Proposal for Supplement 2 to the 01 series of Amendments to UN Regulation No. 141

Amendments to ECE/TRANS/WP.29/GRBP/2022/2

Submitted by the Task Force on Tyre Pressure Monitoring System and Tyre Installation*

“Figure 1
Refilling check

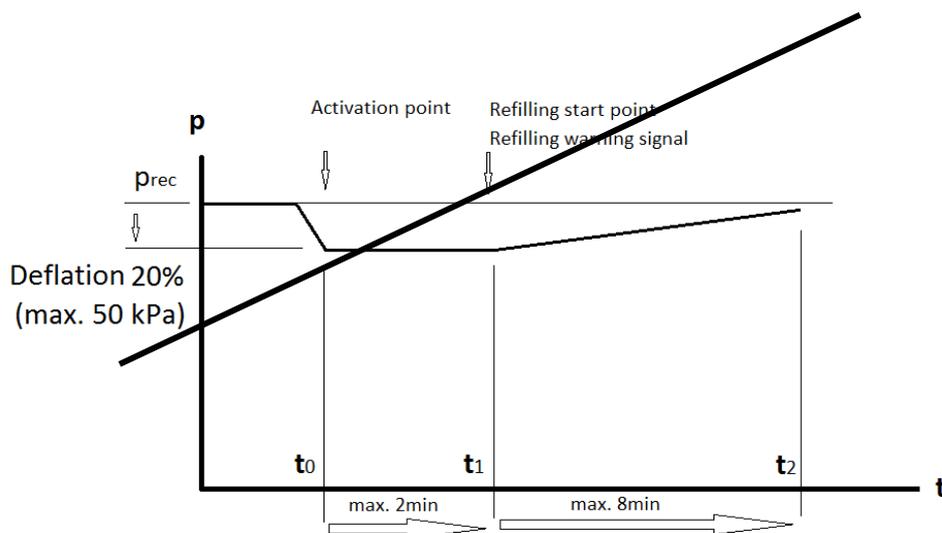
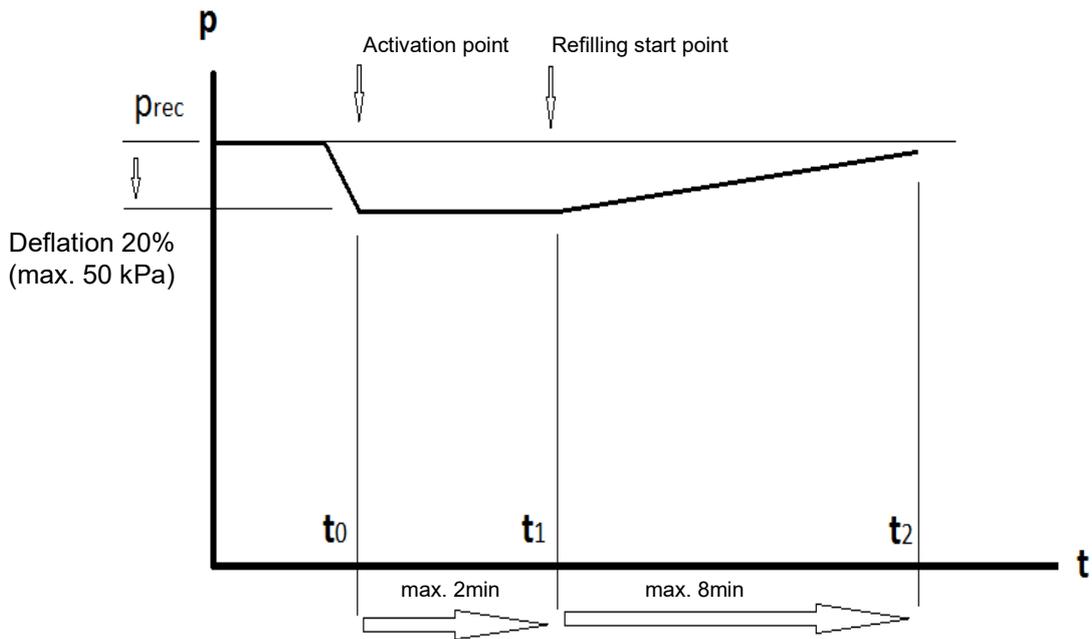
“2.5.2. Check refilling according to Figure 2

Check that within 2 minutes when the system is operational the TPRS/CTIS starts refilling and at least after 2 minutes the low tyre pressure tell-tale, as described in paragraph 5.5. of the regulation, is “On”.

Refill process shall not be completed within 8 min after the refill process has started and the low tyre pressure tell-tale, as described in paragraph 5.5. of the regulation, is “ON” after at least 2 minutes of refilling time.

The deflation rate during the test must be higher than the refilling rate.”

Figure 1, amend to read:

Check that within 2 minutes, when the system is operational, the TPRS/CTIS starts refilling and at least after 2 minutes the low tyre pressure tell-tale, as described in paragraph 5.5. of the Regulation, is “On”.

Refill process shall be completed within 8 min after the refill process has started and the low tyre pressure tell-tale, as described in paragraph 5.5. of the Regulation, is “Off” as soon as the refilling process is completed.

After the refilling process has been completed, check that the tyre pressure is in a range of +/- 5% of manufacturers recommended cold inflation pressure P_{rec} .”

Checking system malfunction warning functionality.

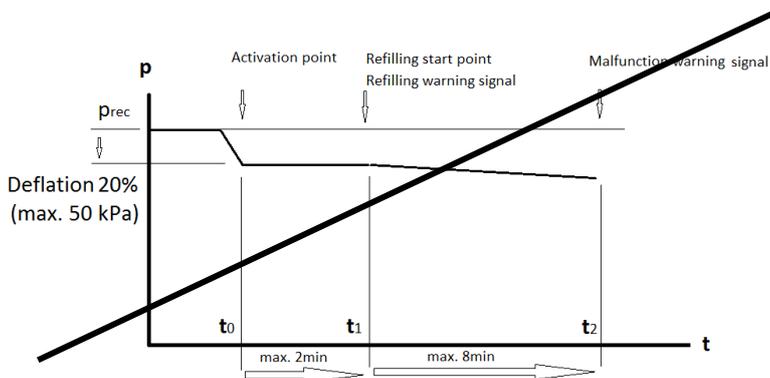
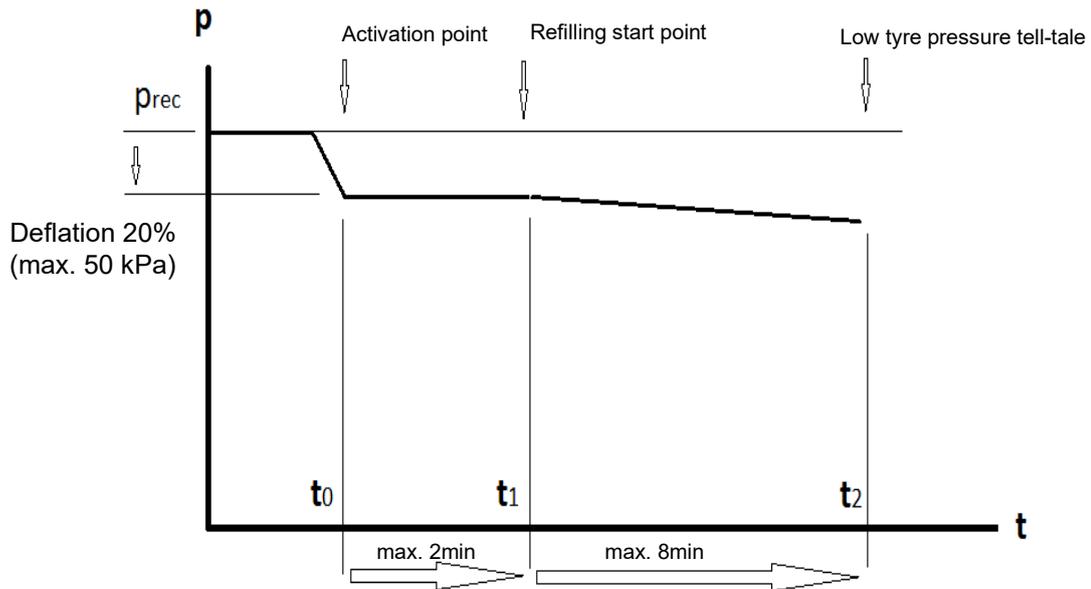
Figure 2, amend to read:

“Figure 1
Arrangement of device under test and vehicle simulator where TPMS/ TPRS/ CTIS functionality is provided by ECU connected via ISO 11898-1:2015 and 11898-2:2016 interface

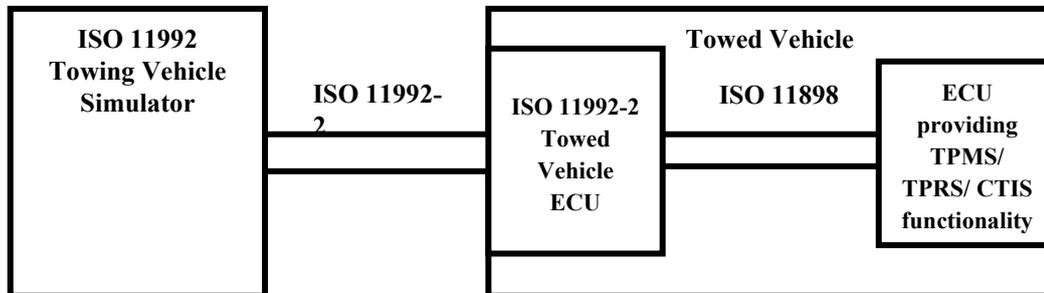
Figure 1, amend to read:

“Figure 2
Arrangement of device under test and vehicle simulator where TPMS/ TPRS/ CTIS functionality is provided by ECU connected to towing vehicle

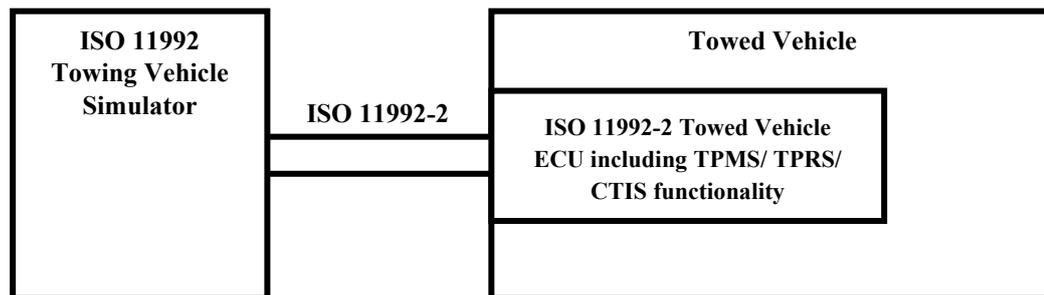
Figure 2, amend to read:
